Advisory Board on Radiation and Worker Health  
National Institute for Occupational Safety and Health

**Focused Review of ORAUT-RPRT-0092, Revision 00, and  
Remaining Petition SEC-00103 Evaluation Report Period:  
1991–2007**

**Contract No. 75D30119C04183  
Document No. SCA-TR-2022-SEC001, Revision 0**

April 22, 2022

Figure 1. Fraction of total mandated bioassays that were listed on the RWP versus year

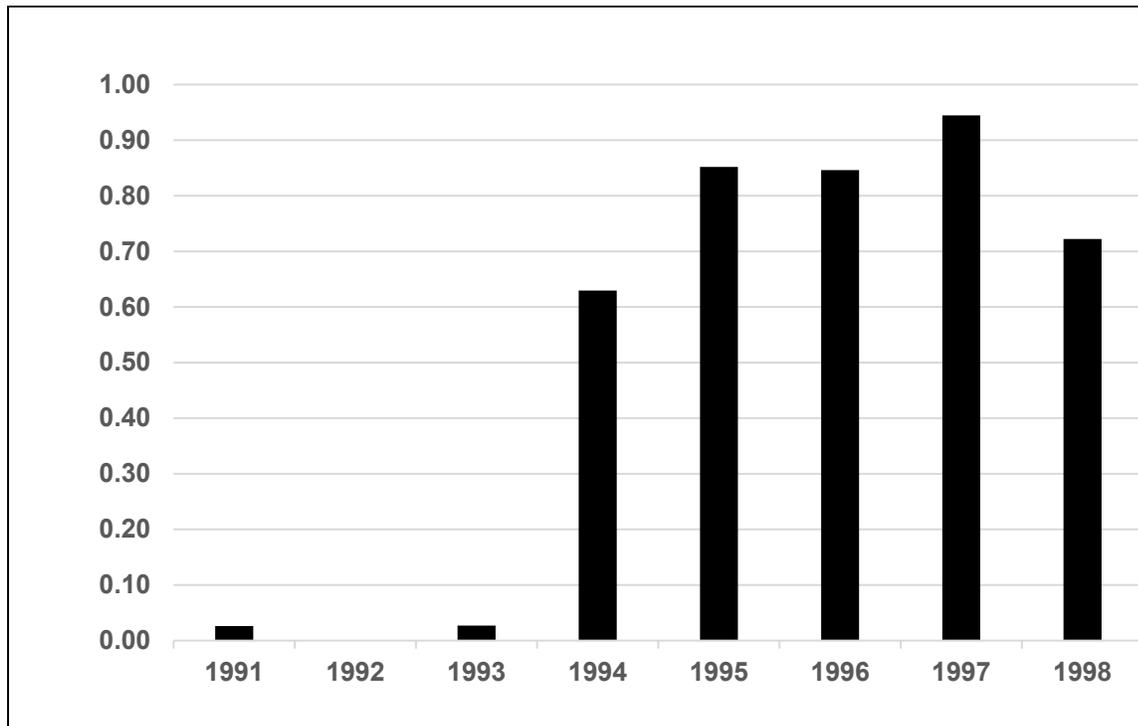
The results in figure 1 and table 2 indicate that RWPs began to specify that a bioassay was required for certain radionuclides in the mid-1990s (1994 to 1995).

Figure 2. Figure 4-4 from RPRT-0092: attachment 2 to root cause analysis corrective action report

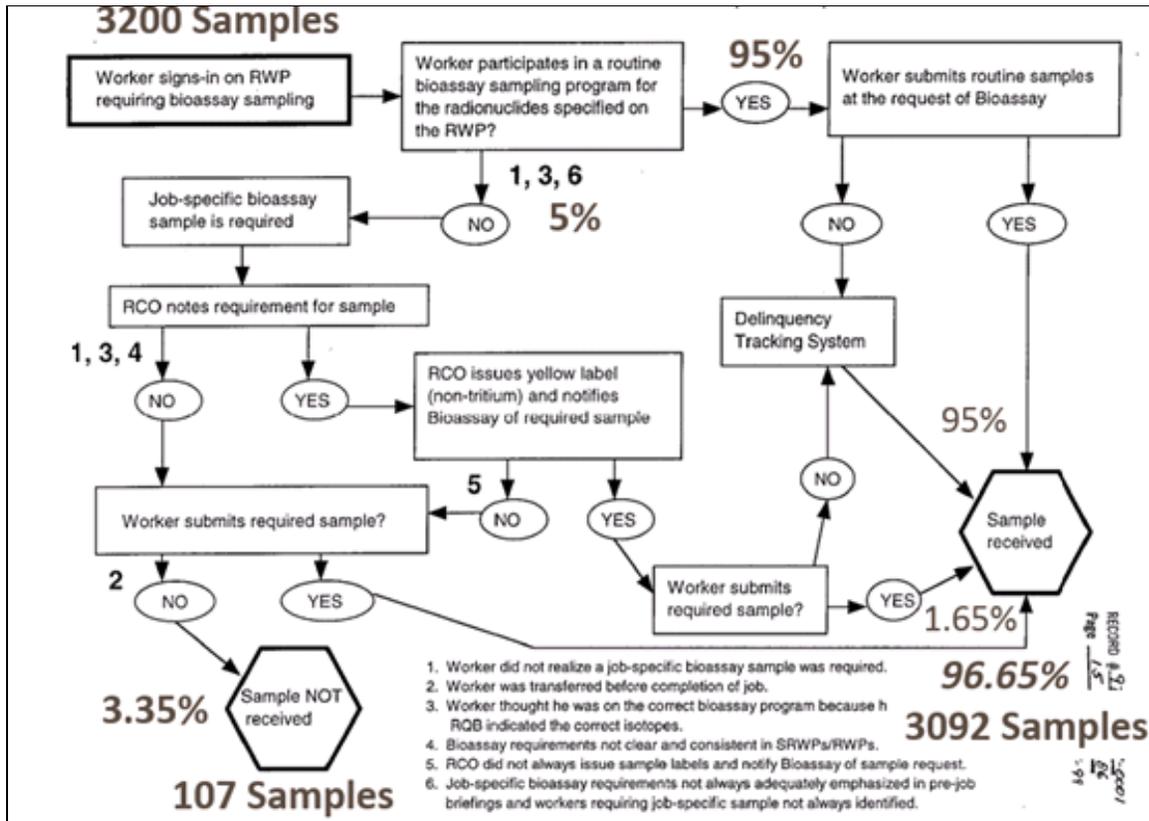
A more significant issue is that the data used in RPRT-0092 appear to have failed to identify the missed job-specific bioassays as outlined in figure 4-4, page 39, of RPRT-0092 (NIOSH, 2019a; reproduced here as figure 2), which was taken from WSRC (1998d). The flowchart is the expected process; the large numbers represent actual first four months of 1997 participation as analyzed in May 1997 (NIOSH, 2019a, p. 38).

Figure 3. Percent of directly and effectively monitored sCTWs per RWP-mandated bioassays (R + A)

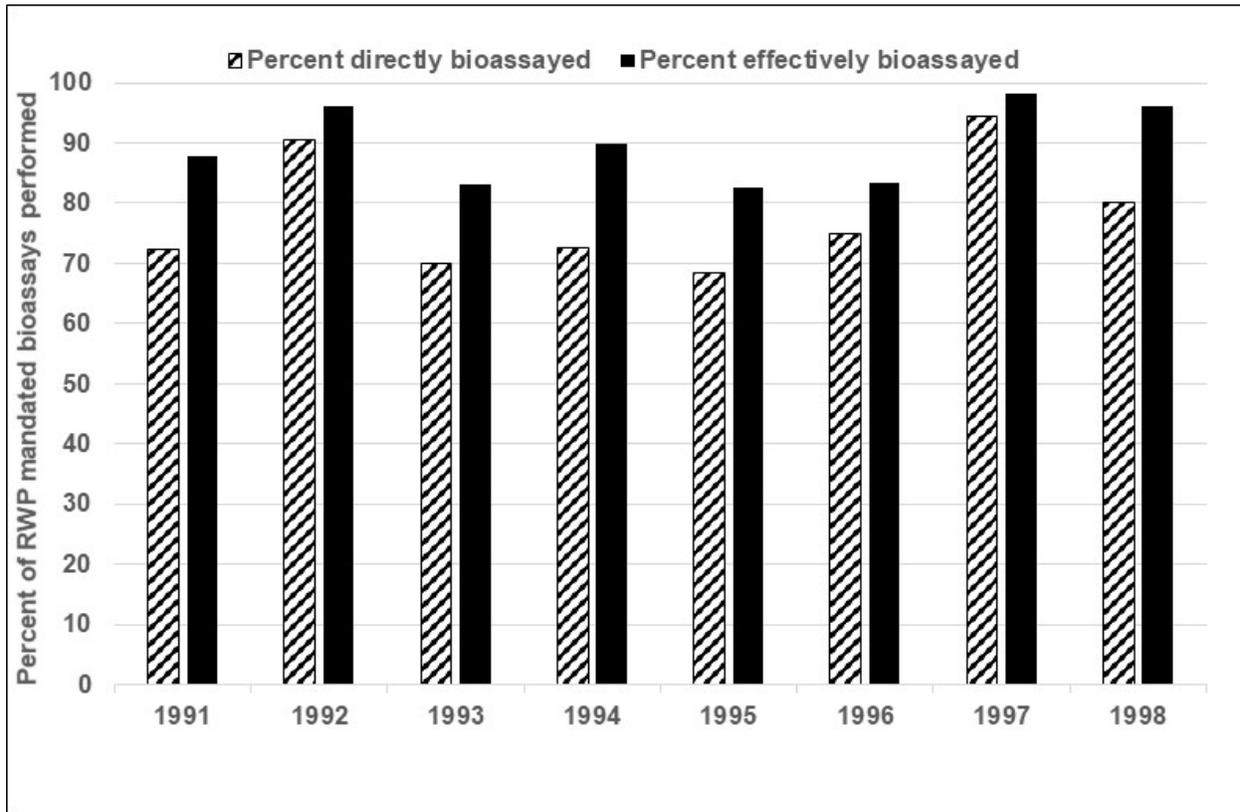
However, the mostly routine bioassay data tend to overshadow the missed sCTW job-specific bioassays, such as those in the set of 107 missed bioassays during the first four months of 1997, as referred to in figure 4-4 and page 38 of RPRT-0092. The much lower number of job-specific bioassays would not have the potential to provide a significant impact on the overall percent monitored.

*Figure 4. Directly bioassayed radionuclides with 1991–1994 noncompliance fraction greater than 1995–1998 noncompliance fraction*

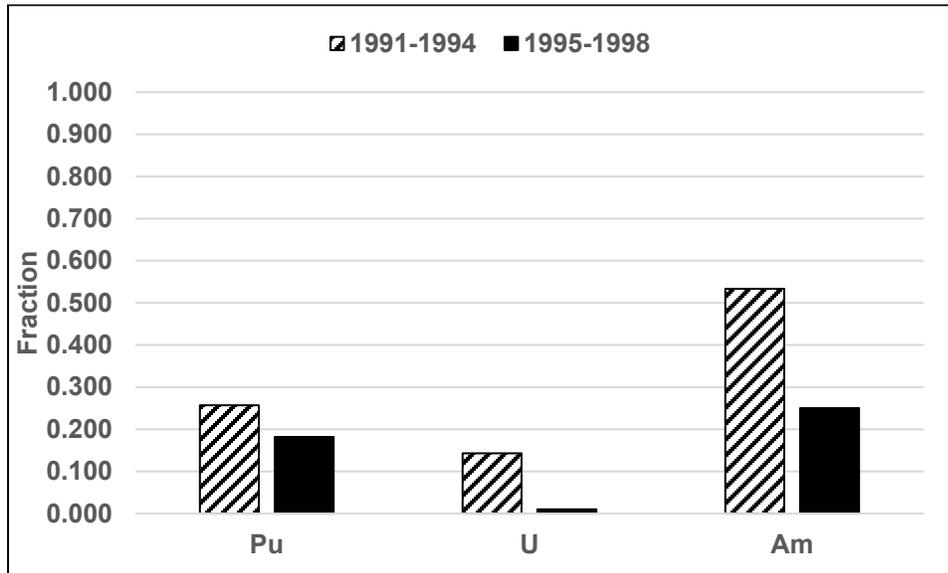
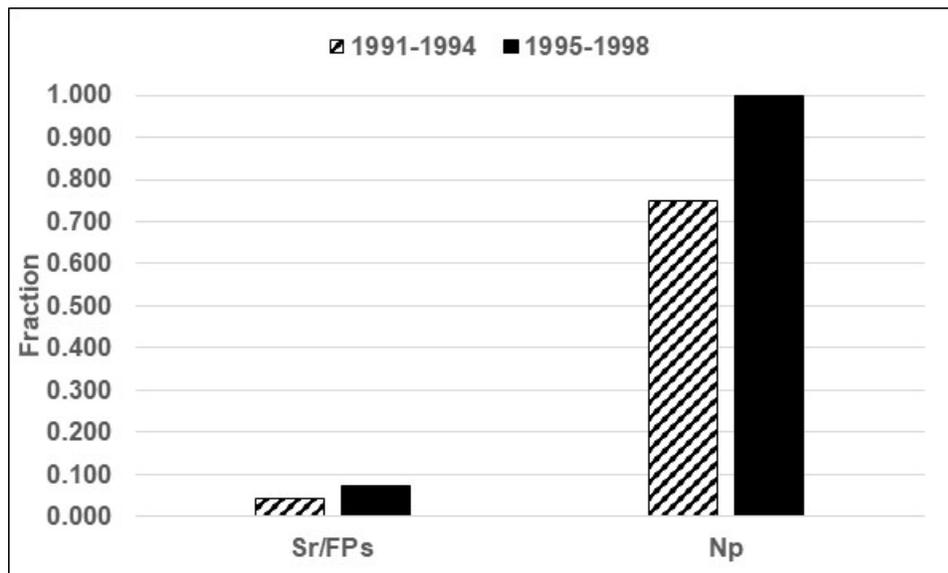
SC&A further analyzed the results in terms of noncompliance as a function of radionuclide and year. For the purpose of this exercise, SC&A selected <80 percent as an arbitrary threshold for direct bioassay monitoring for an area or building, below which compliance would certainly be questionable. SC&A divided the results into two periods, 1991–1994 and 1995–1998, to see if there was any obvious step function that would indicate a greater compliance rate after 1994 when RWPs began to be more prescriptive. However, there does not appear to be a defining inflection point. Figures 4 and 5 summarized the results for sCTWs directly monitored. In these two figures, a high fraction of missed bioassay results means poor compliance. The results were mixed. For example, bioassay noncompliance was greater for plutonium, uranium, and americium for 1991–1994 (taller hashed bars) compared to 1995–1998 (shorter black bars) as shown in figure 4, but Sr/FPs and neptunium bioassay noncompliance was greater for 1995–1998 (taller black bars) compared to 1991–1994 (lower hashed bars) as shown in figure 5. However, there were only three RWPs with 11 workers for 1995 for neptunium. Americium and neptunium had a greater amount of noncompliance (ranging from 20 to 100 percent) compared to plutonium, Sr/FPs, and uranium (noncompliance ranged from zero to 24 percent), perhaps because plutonium, Sr/FPs, and uranium were more likely to be covered by routine bioassays whereas americium and neptunium radionuclides were not as common (and more likely to be on job-specific bioassays). As mentioned previously, for some radionuclides there was an insufficient number of RWPs in the 1995–1998 period to provide statistically significant results.
